**IN THE MATTER** of Plan Change 58 to the Matamata-Piako District Plan

**Joint Witness Statement (JWS) – Noise**

**Attachment 3: Amended Avenue Business Park Development Area Plan**

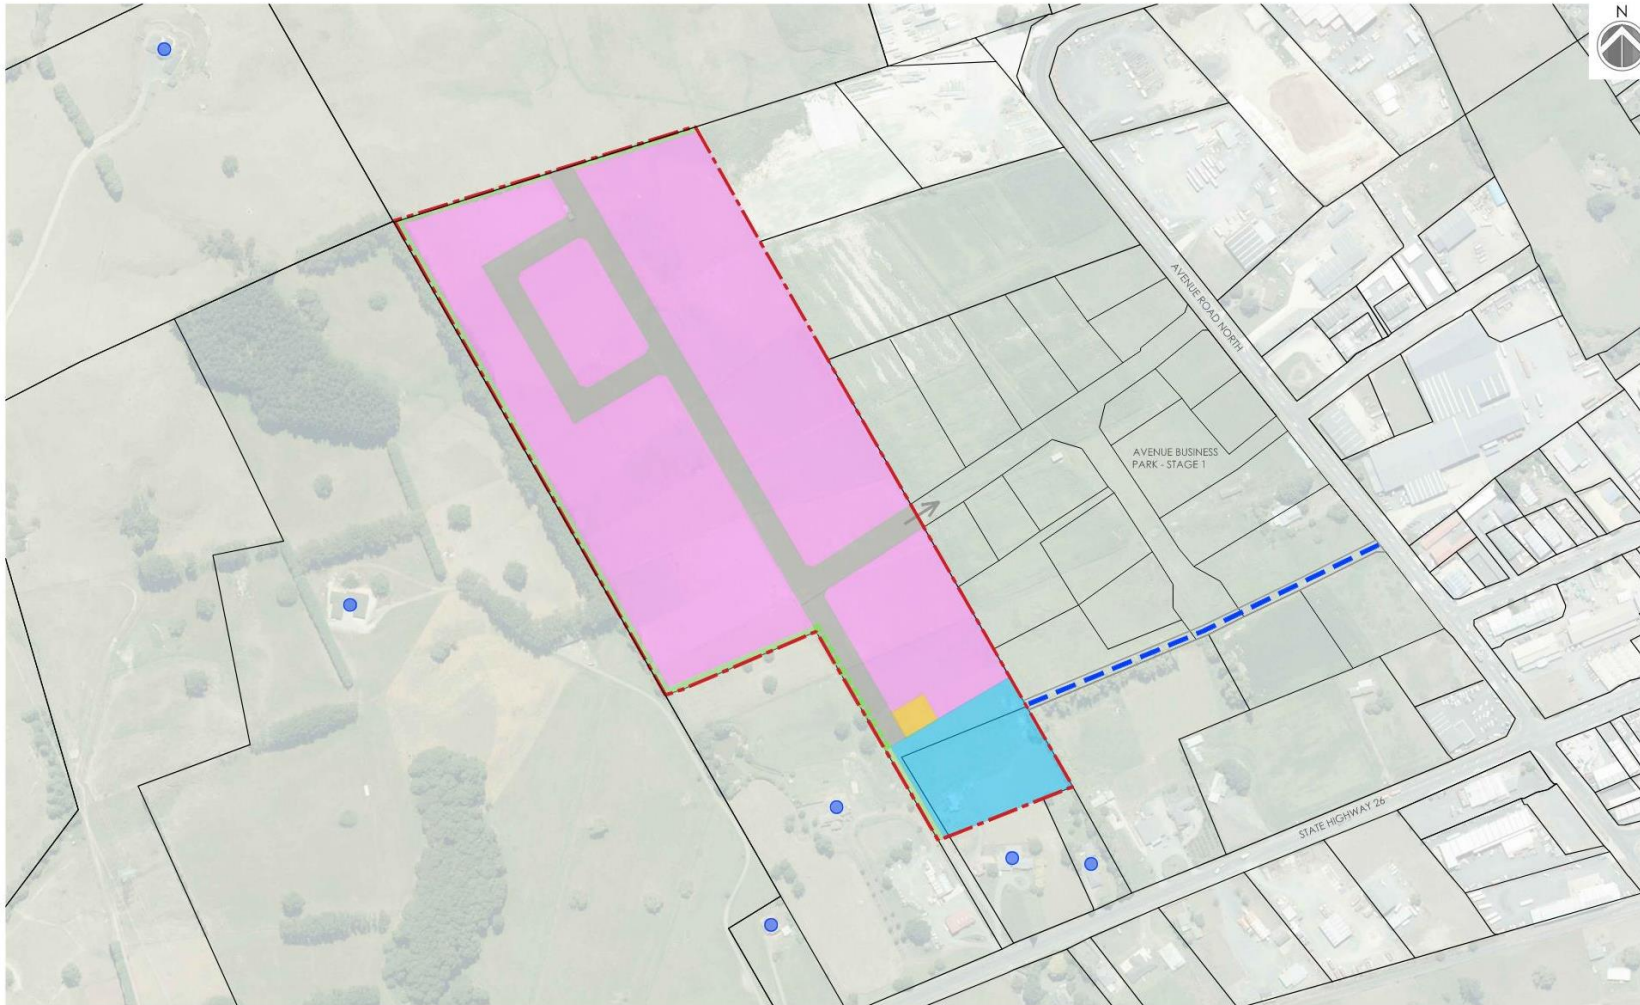
22. NS explained that MPDC has concerns that it could be unclear to users of the district plan which residential units in the GRUZ existed at the date of notification of PC58 (which was 15 June 2023).

23. MC, having discussed this with Mr Inger (planner for the Applicant), has attached an updated version of the Avenue Development Area Plan to this JWS (refer to Attachment 3) which shows residential units existing on adjacent Rural zoned properties as of that date.
